UNITED STATES PATENT AND TRADEMARK OFFICE

10/507,497

Office Action Summary

DETAILED ACTION

FIG. 4

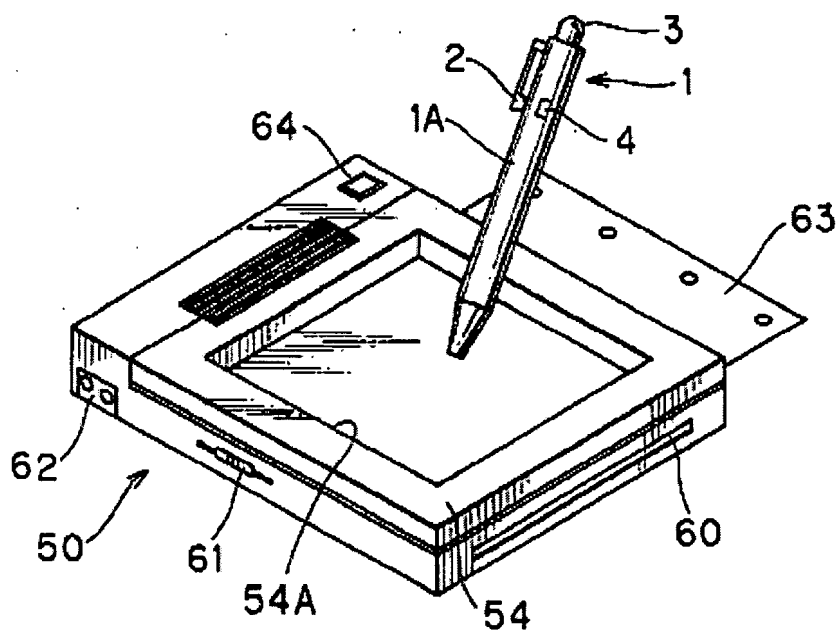
d. As related to independent **claim 1**, Kagayama et al. teach a sensor and print-head assembly comprised in a housing (Kagayama et al. – Figures 4 & 7, shown below), controlled by a processor (Kagayama – Figure 7, Reference #55, shown below) connected to at least one first electronic memory (Kagayama – Figure 7, Reference #56, shown below), comprising at least one sensor means (Kagayama – Figure 7, Reference #41 & #42, shown below), a print-head array (Kagayama – Figure 7, Reference #10, shown below), input means (Kagayama – Figure 4, Reference #3, #4 & #64, shown below), and means for keeping track of the assembly's and print-head's position on a print medium (Kagayama – Figure 7, Reference #41 & #42, shown below).

FIG. 7

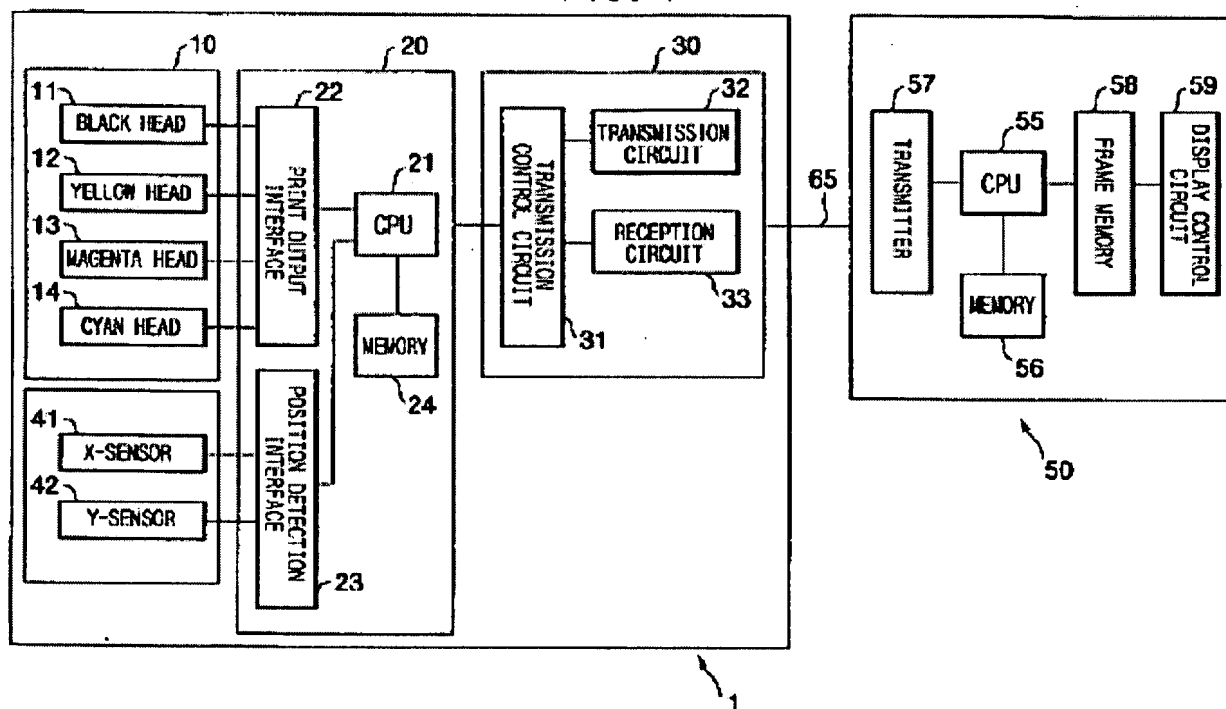
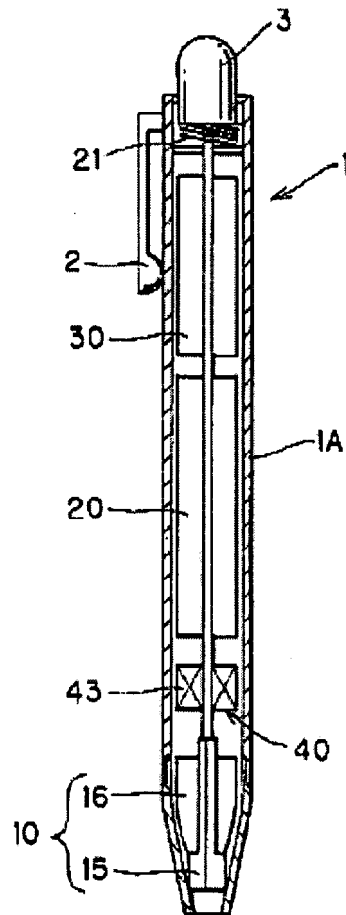
- e. Continuing with **claim 1**, Kagayama et al. teach the processor is provided a connection to a hardware control arrangement (Kagayama – Figure 4, Reference #4 & #64 and Figure 7, Reference #65, both shown previously & Detailed Description, Column 3, Lines 29-32). Additionally, Kagayama et al. teach the arrangement comprising a programmable logic means (Kagayama – Figure 7, Reference #21, shown previously), connected to at least one second electronic memory (Kagayama – Figure 7, Reference #24, shown previously), and having input means for receiving measurement signals from said at least one sensor (Kagayama – Figure 7, Reference #23, shown previously).
- f. As related to dependent **claim 2**, Kagayama et al. teach the print-head is of the ink-jet type with spray nozzles (Kagayama et al. – Detailed Description, Column 3, Lines 36-40 and Figure 1(b), Reference # 10, shown below).
